Addendum to Aggleston Mire Peat Restoration Historic Environment Assessment.

The restoration proposals for Agglestone Mire have been revised in a small section of channel in the centre of the Site. This addendum considers the impact of the revised proposals.

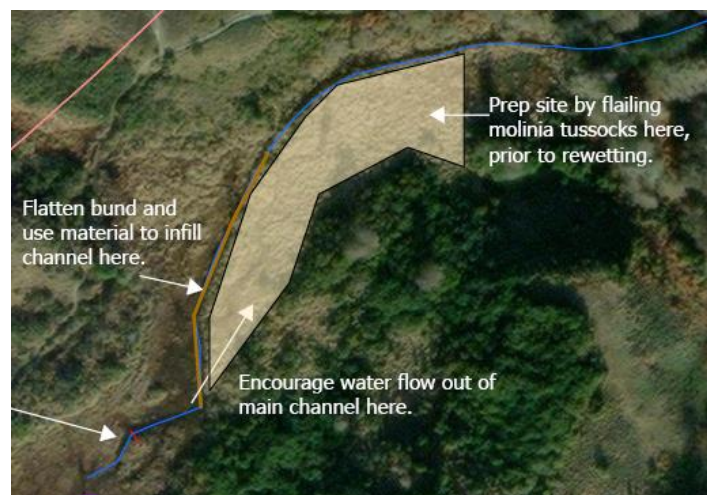
The proposals have been altered to include filling a section of channel. The channel will be filled with material that was excavated for its construction and currently forms a bund on its southeast side.

The blocking will affect about 50m of the ditch. Most of the feature will not be affected and the overall course will be preserved; in addition, the feature will survive below ground as a cut feature although visibility will decline as the restoration of the peat slowly progresses. Overall, the impact is considered very low and no mitigation is recommended. The feature is recorded in existing sources and the GIS data from this report will be sent to the DHER.
